WATER PERMIT NO. 8909-3

**RECOMMENDATION OF CHIEF ENGINEER FOR WATER PERMIT
APPLICATION NO. 8909-3, Tim Neugebauer**

Report to the Chief Engineer

On Water Permit Application No. 8909-3

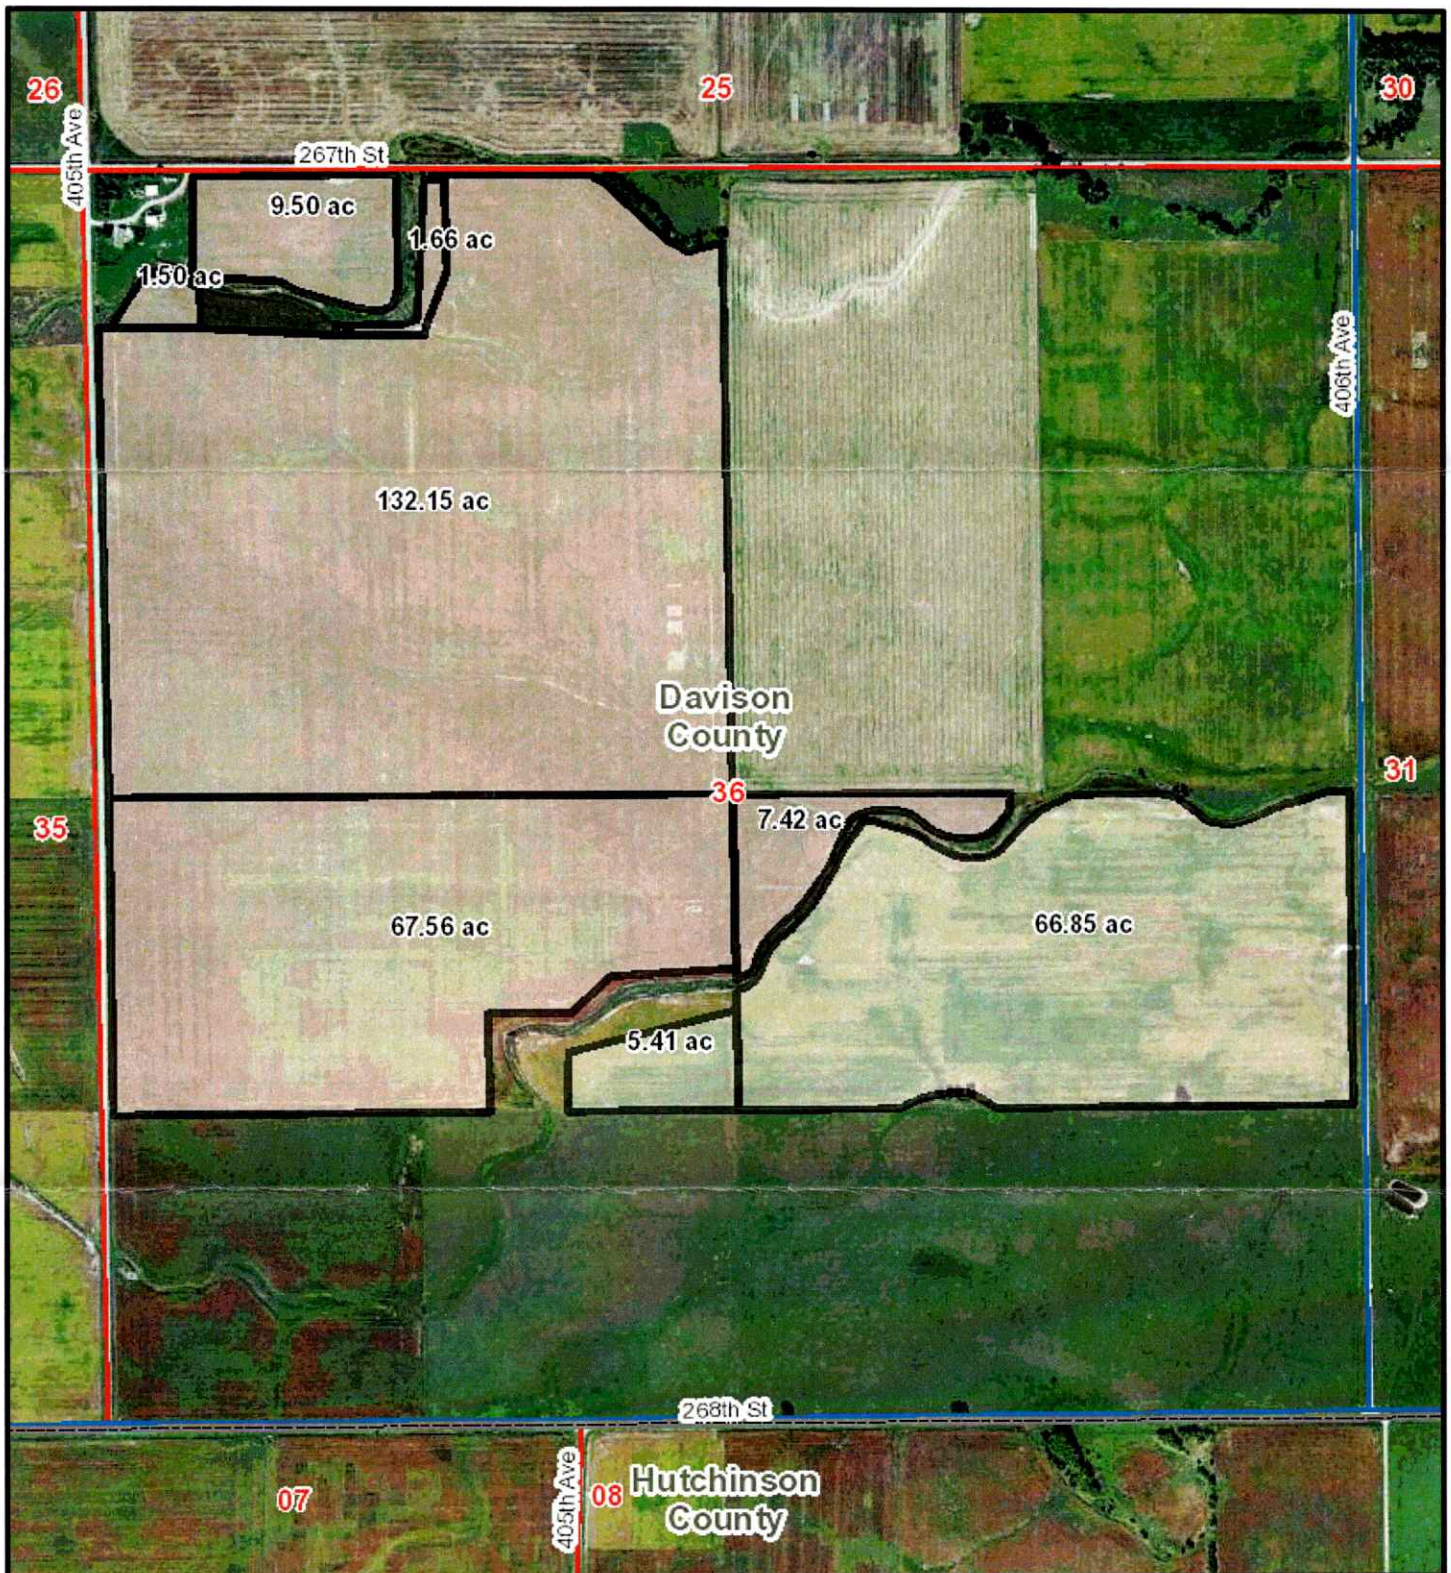
1. I cannot determine the GPM, please see attached highlighted in yellow, is it 1,000 or 1,200?
2. I do not see a diversion point indicated on the map, see attached. Please mark the location of the proposed well with an "X".
3. You indicated that a test hole has been drilled. If available, please provide a copy of the well completion report.

1000 gallon. Well will be right in yard
Test well was just to verify depth of water
